PLANNING COMMISSION MEETING AGENDA

City of New Prague

MEMORANDUM

TO: PLANNING COMMISSION
FROM: KEN ONDICH, COMMUNITY DEVELOPMENT DIRECTOR
EVAN GARIEPY, PLANNER
SUBJECT: CONCEPT REVIEW OF HARVEST FIELDS SINGLE FAMILY RESIDENTIAL DEVELOPMENT CONSISTING OF 185 LOTS ON 63.05 ACRES ON LAND GUIDED AS R1 SINGLE FAMILY RESIDENTIAL AND RM MEDIUM DENSITY RESIDENTIAL, AS PROPOSED BY JPB LAND, LLC, APPLICANT.
DATE: 7/16/2026

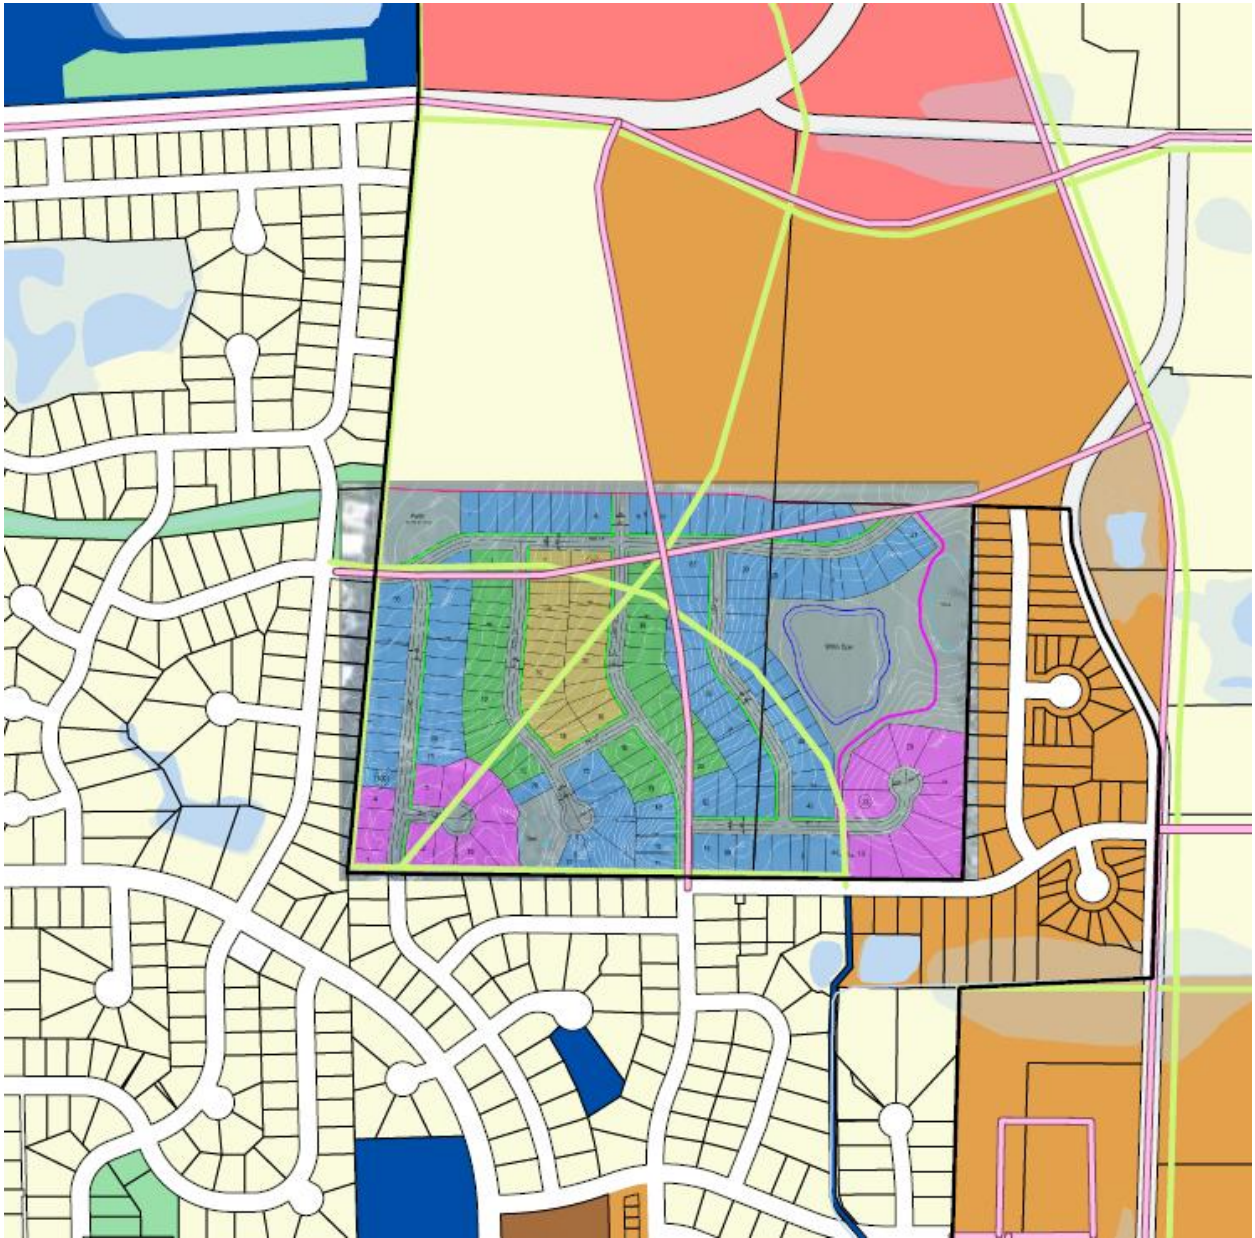
- Ladyslipper Ave. NE as a minor collector (must extend north to a previously identified connection point at 12th Street NE (CR 15) per an MOU with Scott County and Helena Township). This is also reflected in the nearly completed Alton Ave. NE corridor study update.
- Bohemia Street as a minor collector (must extend east to a previously identified connection point at Alton Ave. NE per an MOU with Scott County and Helena Township and additionally as reflected in the new study that is almost completed.)
- All other proposed roads (Ironwood Ave. NE and other unnamed) will be local roads.

Absent having a traffic impact study completed at this time, staff makes a general observation that the connections to existing Ironwood Ave. NE and Ladyslipper Ave. NE are required connections as well as Bohemia Street NE. Staff notes a general lack of alternate roadway connections to the property to the north, however, the traffic impact study will provide more insight into this topic.

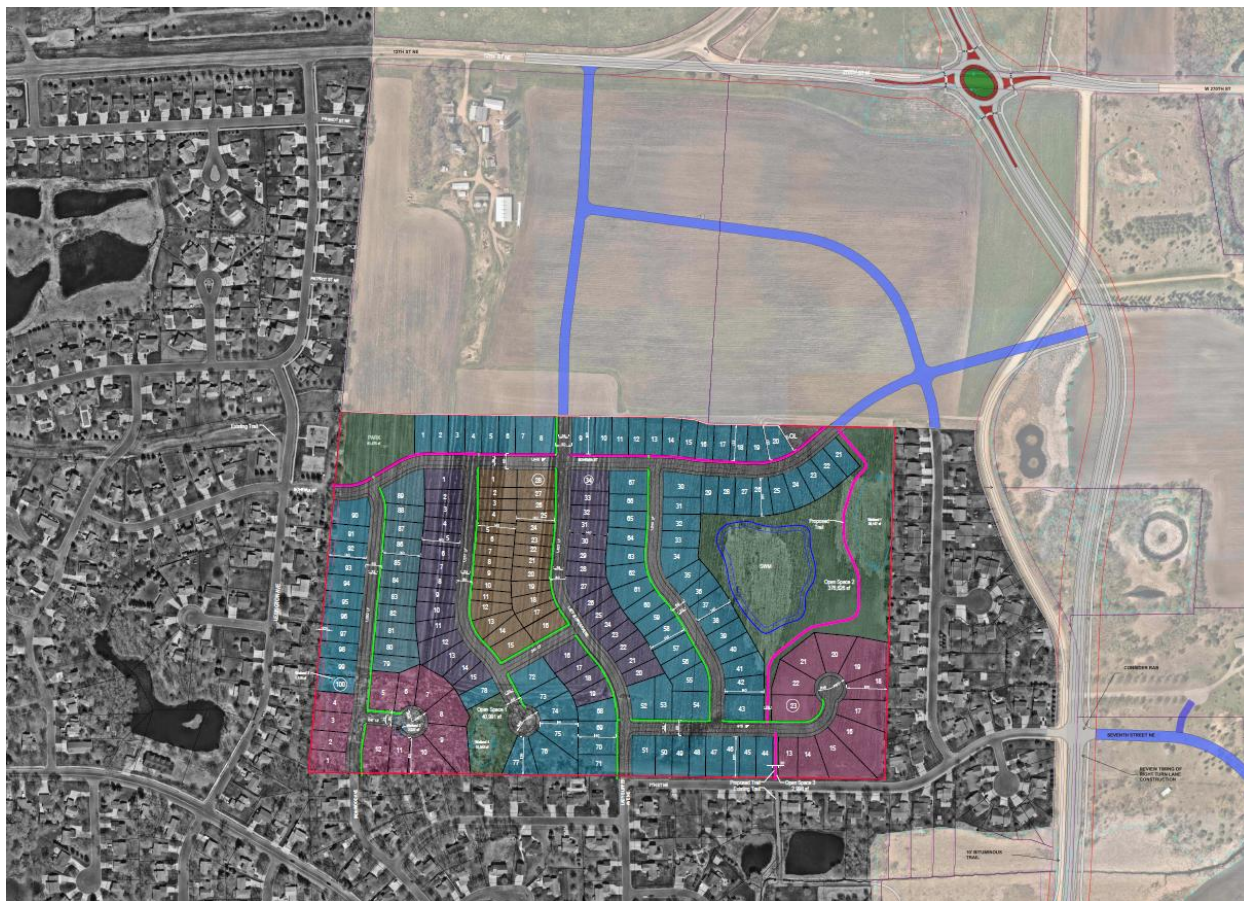
The map below shows the concept plan for the development overlaid on the still ongoing revision to the Alton Ave. NE. corridor study that is expected to be completed by the end of July 2026 between the City, County and Helena Township regarding required connection points for roadways. When said corridor study is completed, the proposed development must continue to fit into those future roadway corridors.

HARVEST FIELDS - CONCEPT PLAN

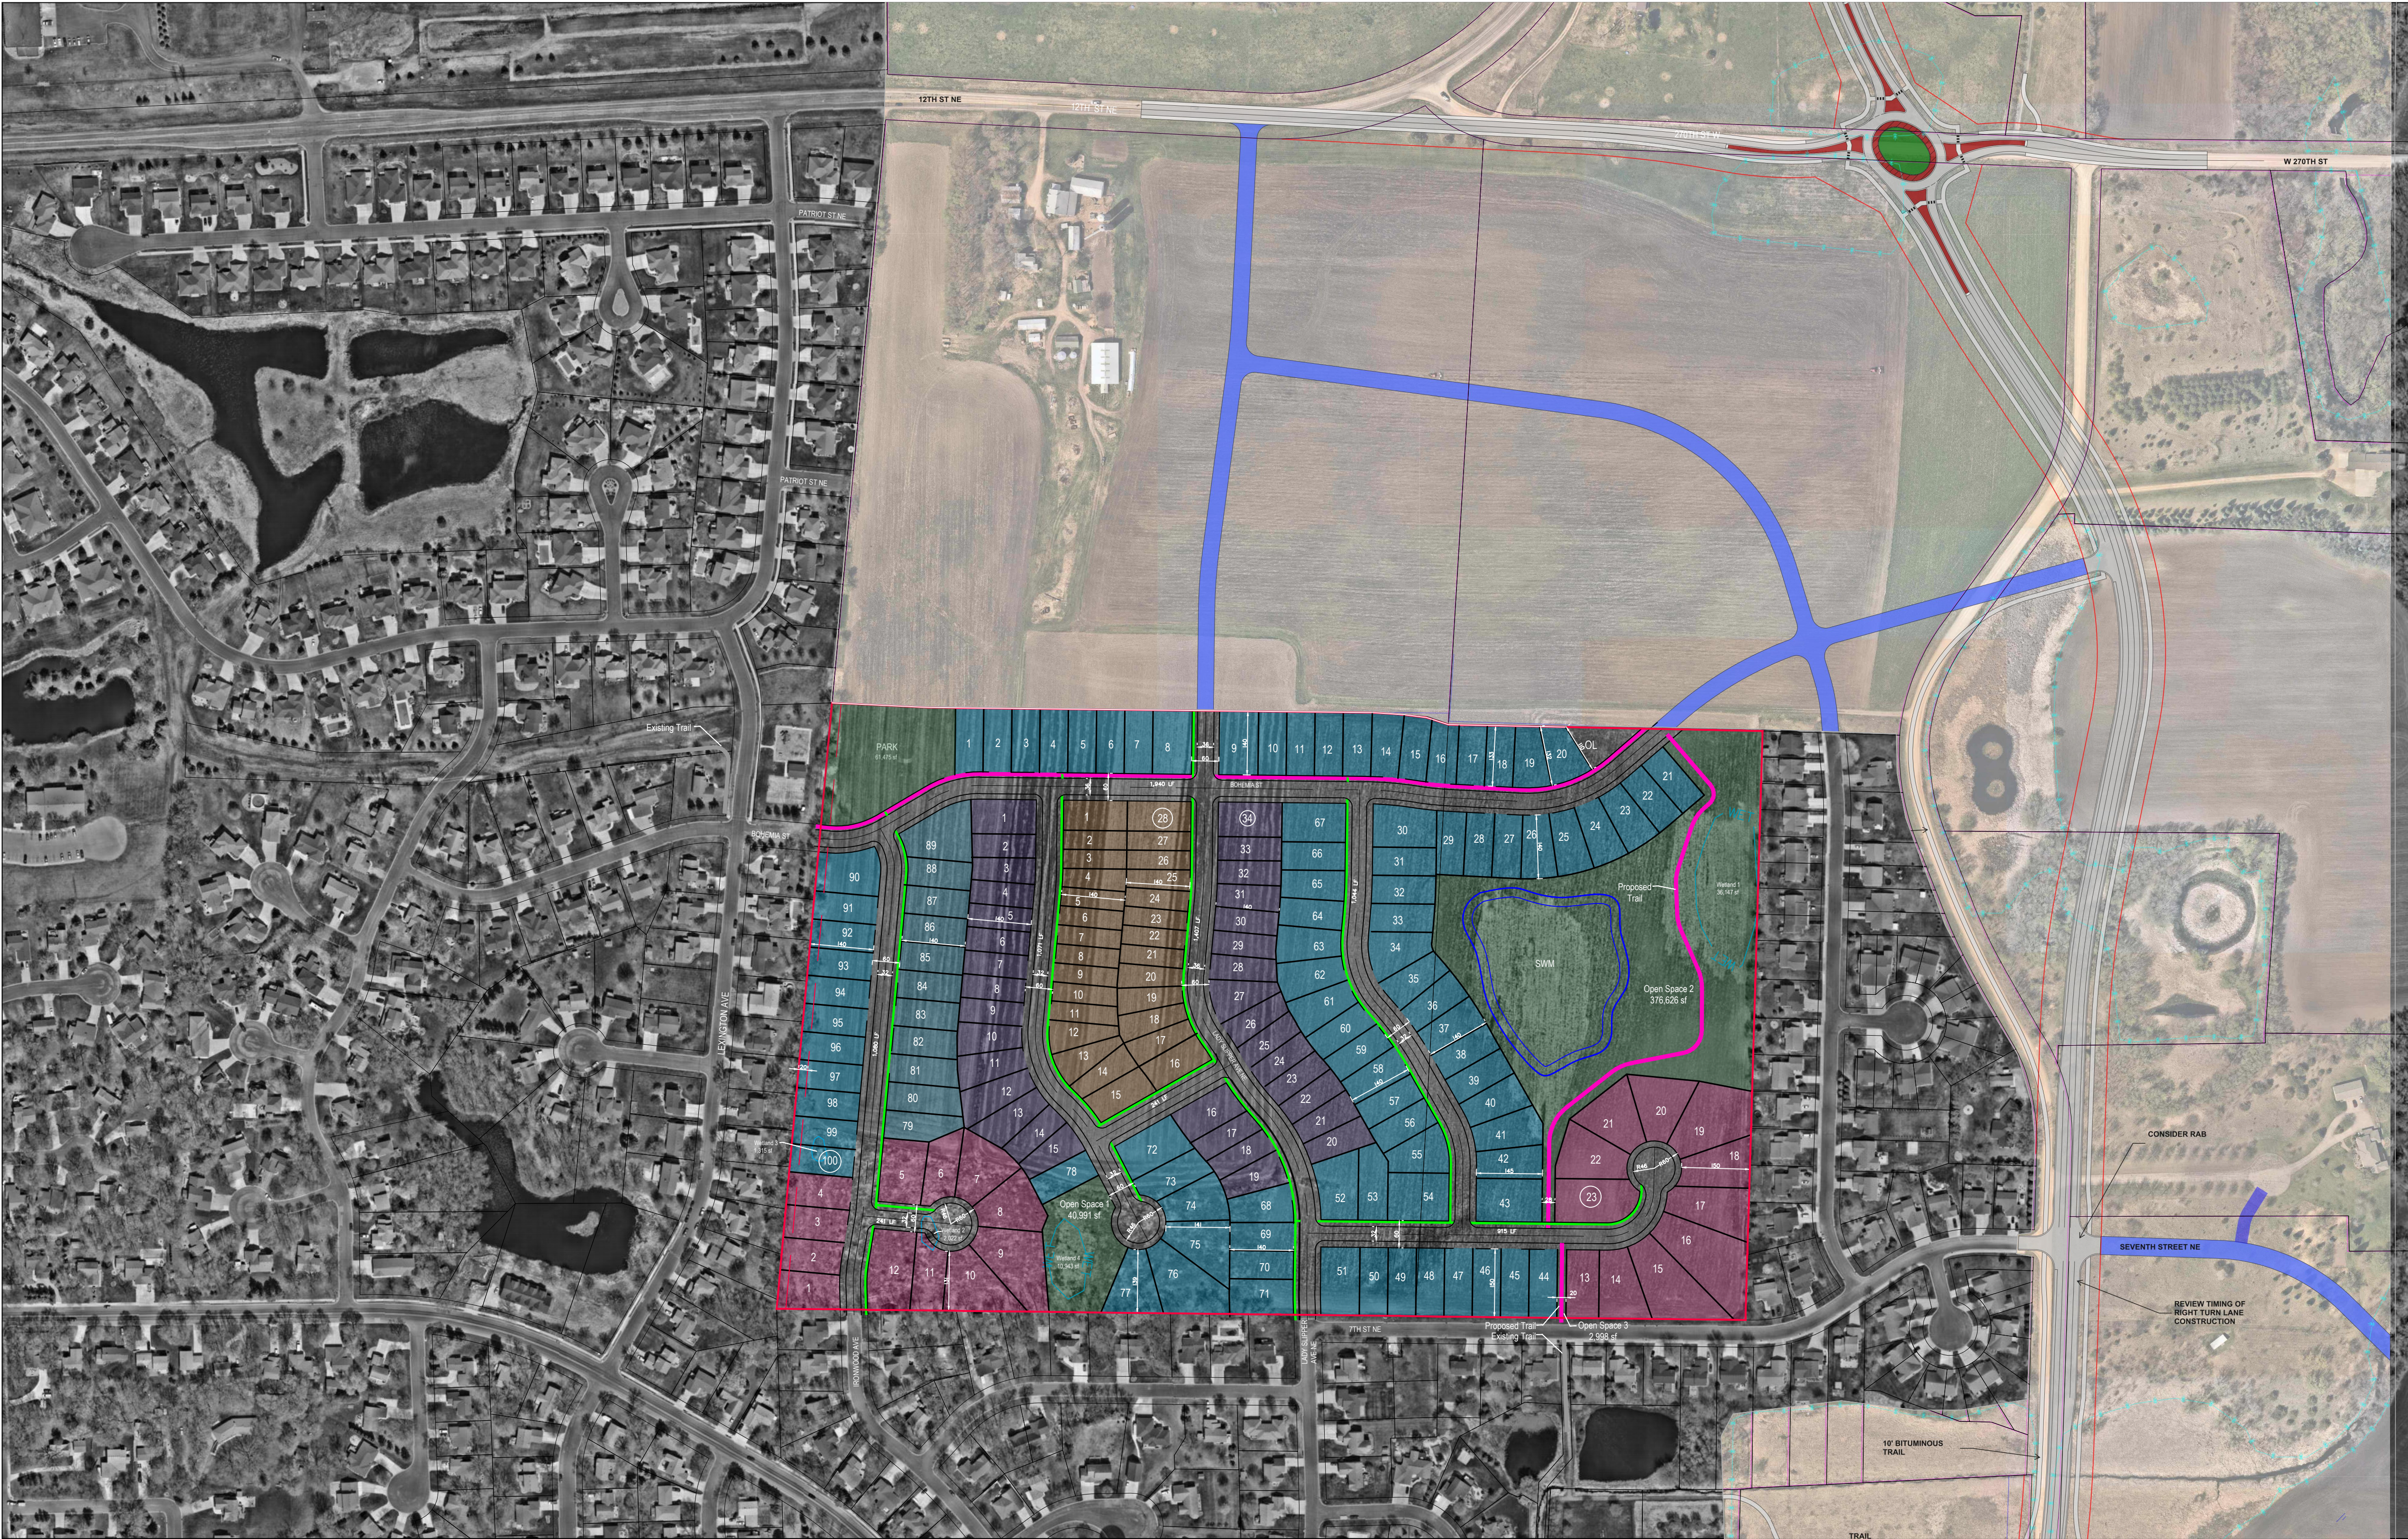
The current concept plan does not meet all of the Unified Development Code's specified density and lot size requirements. Notably, it proposes lot widths down to a width of 42' (which are 8' less than the RM district would allow by right) on up to 72' wide lots which exceed the minimum lot size for the R1 district by 12'. Additionally, a side yard reduction is sought throughout the development from 7' down to 6'. These deviations are allowed if specifically set forth in a PUD plan.

The proposed concept plan shows lots with a width of 42', 52', 62', and 72'. The lots that are 52' in width would be permitted within the RM Zoning District, and the lots that are 42' in width are not permitted by right within either the R1 or RM Zoning Districts. However, this reduction in lot width would be part of the PUD approval process. The proposed overall density is 2.93 units per acre (based on 63.05 net acres) or 3.56 units per acre based on net developable area of 51.90 acres (removing the wetlands and pond/park/open space areas).

It appears that two of the wetlands (#2 and #3 in the SW corner) would be impacted by the development and would need to be mitigated (replaced) according to WCA requirements. An application to mitigate these wetlands has not been submitted at this time.

Discussion also occurred regarding the greenway as it first enters into the development and the fact that it crosses a local street almost immediately and that the developer should look at the ability to route the greenway along the east side of the cul-de-sac to avoid the additional road crossing.
